OPTima and Lite

Operator Station Firmware Update CPU V3.2/Comm V1.6 (for use with Kit Number 71-999-J)

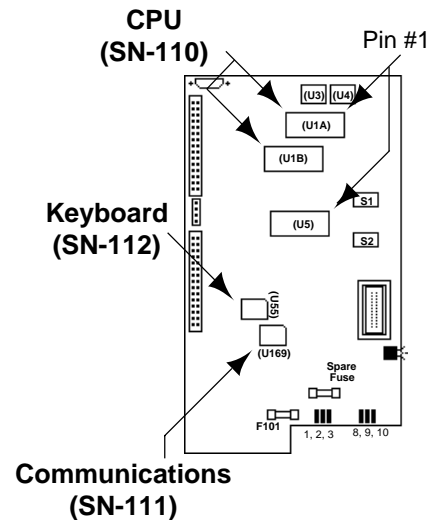
A new feature was also added that (in some cases) prevents the operator station from coming out of screen blanking: if S2, Position 2 is placed in the "closed" position, then pressing any of the machine function keys will NOT "unblank" the screen.

In addition, any action that would cause the following messages to appear would normally (without S2, Position 2 being closed) cause the screen to "unblank." With S2, Position 2 in the closed position, these messages will display but will NOT "unblank" the screen.

278	Setpoints Limit Error
336	Setpoints Restored
515	Reading Setpoints
516	Saving Setpoints
517	Setpoints Saved

Note that for 128K of memory, U3 is installed. For 256K of memory, U4 is added. For 384K of memory, U5 is added.
